AS-CONSTRUCTED

Clark Consulting Engineers		19 Ryan Road Edgewood, New Mexico 87015	
Tel: (505) 281-2444		Fax: (505) 281-2444	
DATE	REVISION	LOTS A AND B, BLOCK 5, BUENA VENTURA ADDITION	
12/22/06	As-Built	DEL TACO ALBUQUERQUE	
1/10/07	" "	10015 E. CENTRAL AVE. NE	
		TRAFFIC CIRCULATION LAYOUT	
DESIGNED BY: PWC	DRAWN BY: CCE	JOB #: Del Taco2	
CHECKED BY: PWC	DATE: 1/10/07	FILE #

GRADING & DRAINAGE PLAN

TRAFFIC CIRCULATION LAYOUT
APPROVED
[Signature]
Date

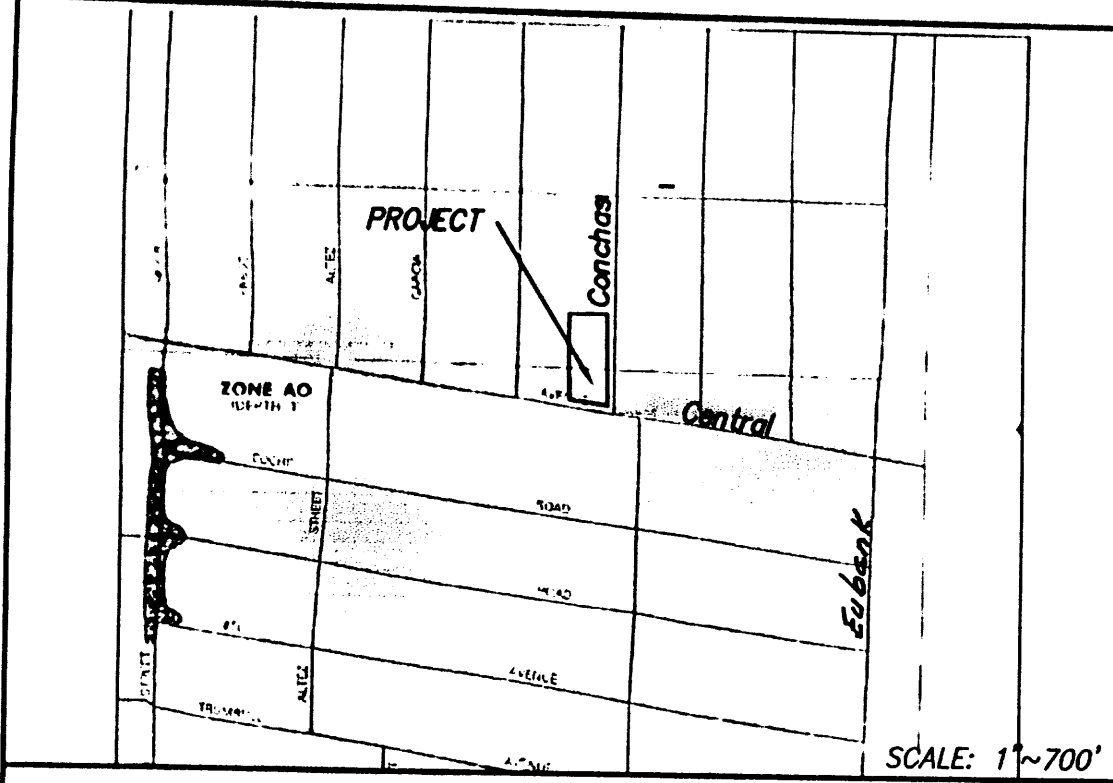
Include (detectable warning surface) & truncated domes
